HISTORIC AND DESIGN REVIEW COMMISSION

HDRC CASE NO: 2020-142
ADDRESS: 1115 NOLAN ST
LEGAL DESCRIPTION: NCB 1665 BLK 1 17 & W 25 FT OF 16
ZONING: R-6 CD, H
CITY COUNCIL DIST.: 2
DISTRICT: Dignowity Hill Historic District
APPLICANT: San Antonio San Antonio/MONGEON CHRISTOPHER &
OWNER: San Antonio San Antonio/MONGEON CHRISTOPHER &
TYPE OF WORK: Amendment to issued COA
APPLICATION RECEIVED: March 13, 2020
60-DAY REVIEW: Not applicable due to City Council Emergency Orders
CASE MANAGER: Huy Pham
REQUEST:

The applicant is requesting a Certificate of Appropriateness for approval to amend the design of new, rear accessory structure approved on February 5, 2020, to feature one, double-wide garage door, instead of two, single-wide garage doors.

Current request - one
double-wide garage door

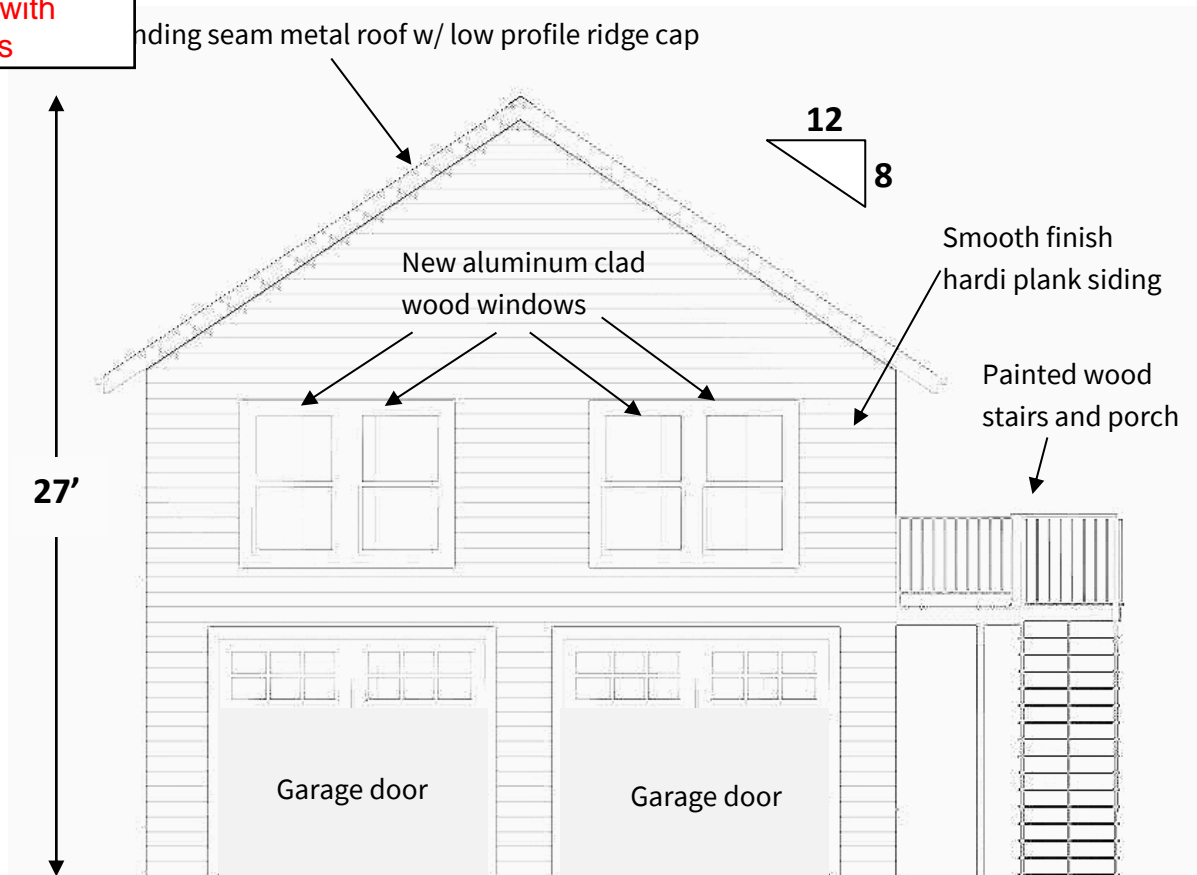
- c. **GARAGE DOORS** – The applicant has proposed to amend the design of the rear accessory structure to feature one, double-width door instead of two, single-wide doors. Per the Guidelines for New Construction 5.A.v., applicants should incorporate garage doors with similar proportions and materials as those traditionally found in the district. Staff finds that double-wide garage doors are not historically found in the district and the garage should feature two separate vehicle bays and door openings. Minor modifications to the garage door widths and/or their spacing may be considered for administrative approval if the two, single-width door configuration remains.

Staff does not recommend approval based on finding c. Minor modifications to the garage door widths and/or their spacing may be considered for administrative approval if the two single-width configuration remains.

East Facing Elevation

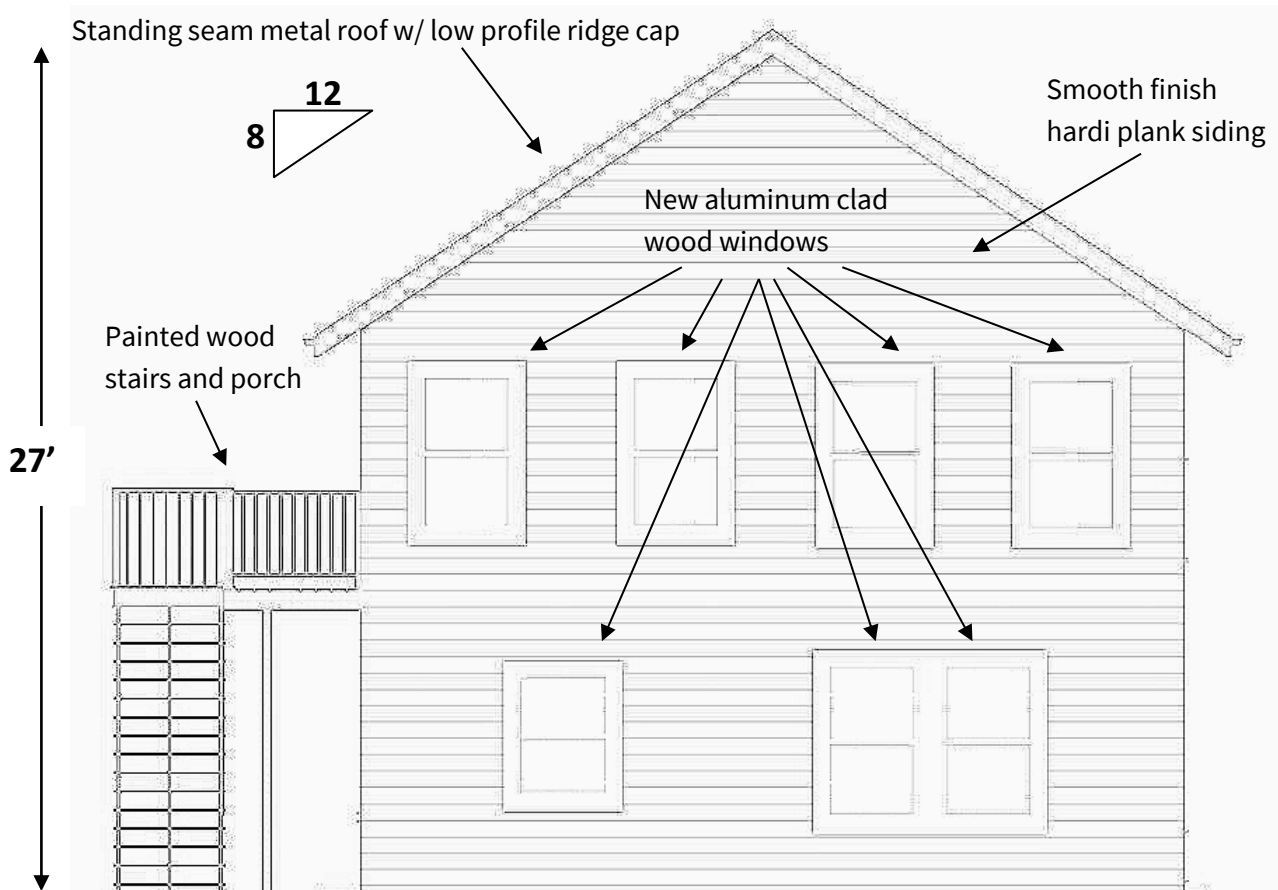
h. GARAGE DOORS – The applicant has proposed garage doors that are single in width and feature top row window lights. Staff finds that the proposed garage doors are generally consistent with the Guidelines.

- i. That all window specifications be adhered to as noted in finding g.
- ii. That the proposed standing seam metal roof feature panels that are 18 to 21 inches in width, seams that are 1 to 2 inches in height, a crimped ridge seam and a standard galvalume finish.
- iii. That all Hardi siding feature an exposure of four (4) inches, $\frac{3}{4}$ " thickness and a smooth finish.

Current Request
One Double Garage Door

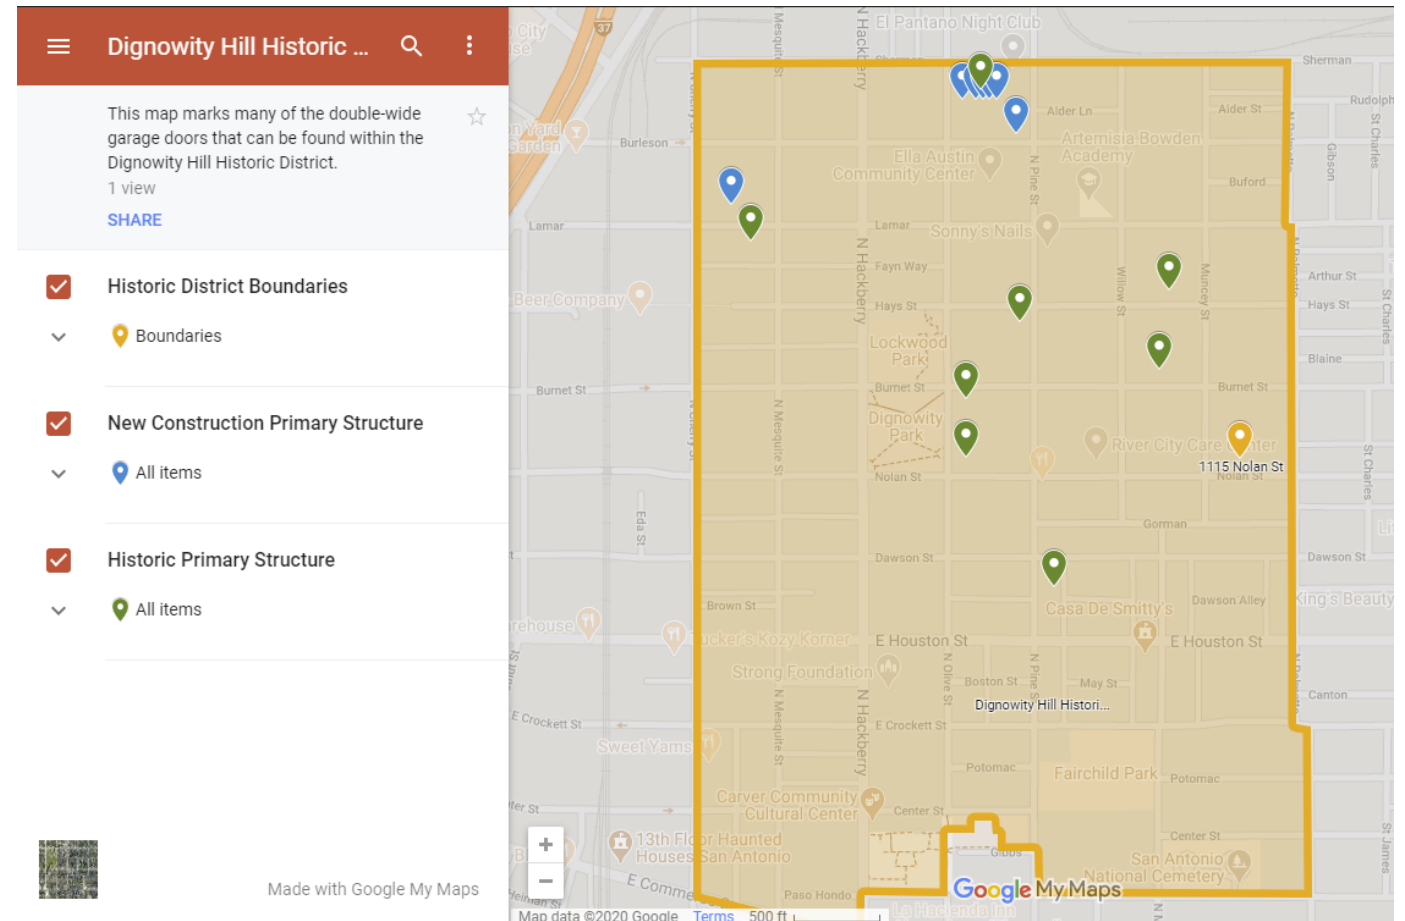
Functional Necessity

Structure placement and driveway were originally designed by my wife and me (non-architects)

Does not comfortably accommodate the turning radius of my vehicle

Least impactful modification is double wide door

There are many examples of double wide garage doors within the Dignowity Hill Historic District

The garage door will not be visible from the street

Garage Door Not Visible Over the Gate/Fence

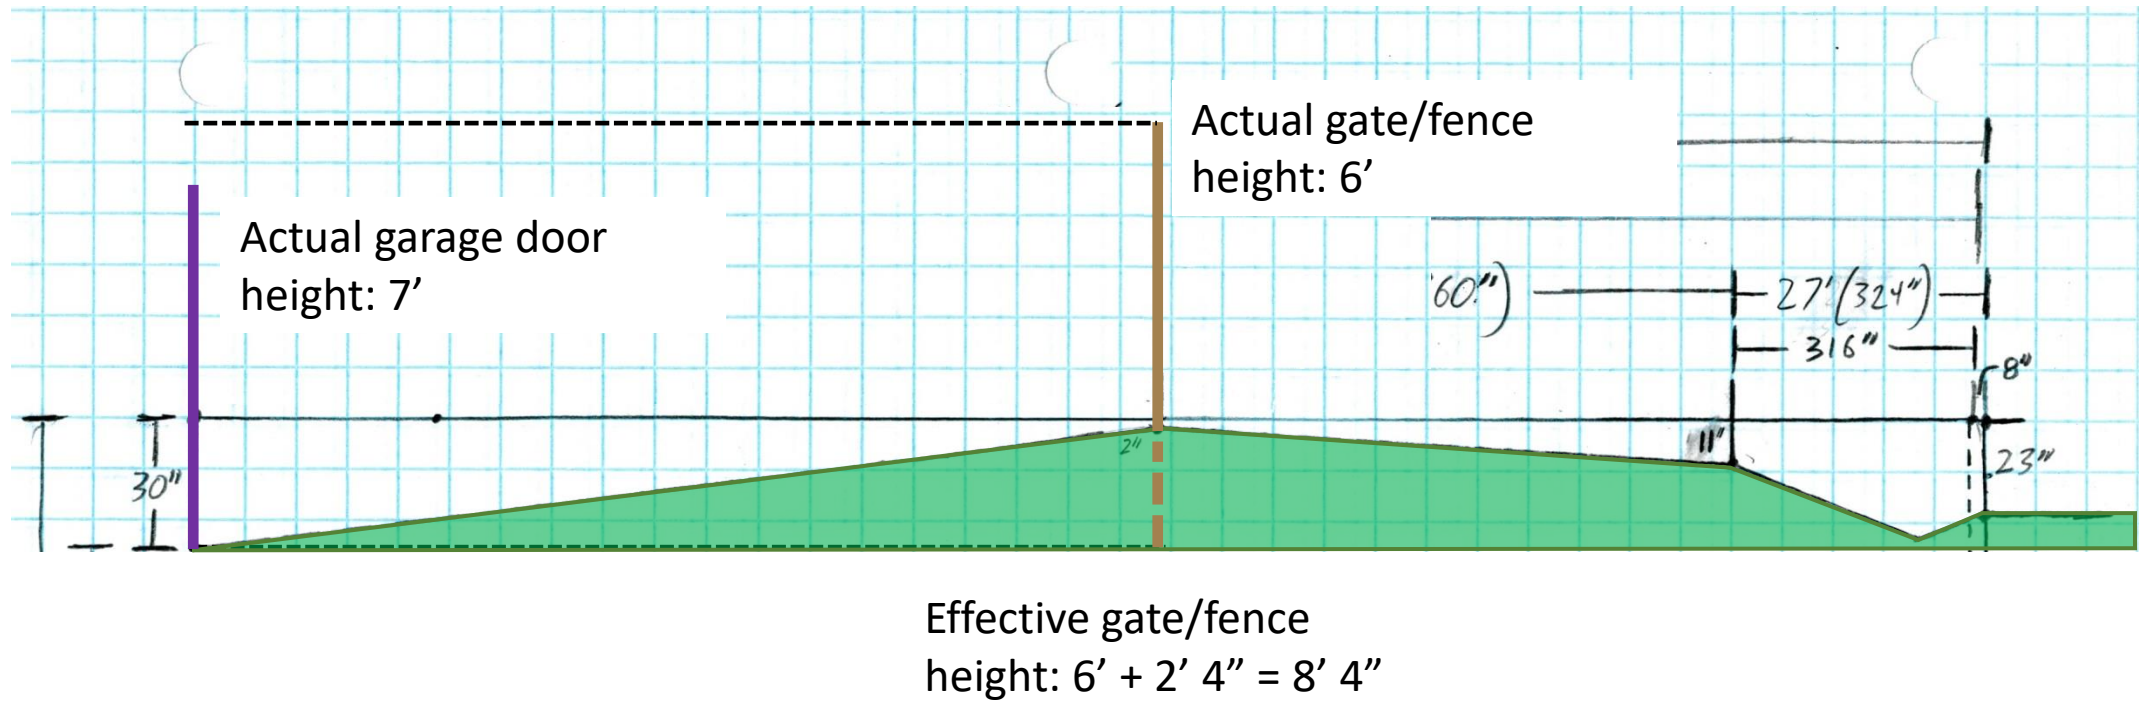
Garage Door Not Visible from the Street

Garage Door Not Visible from the Street
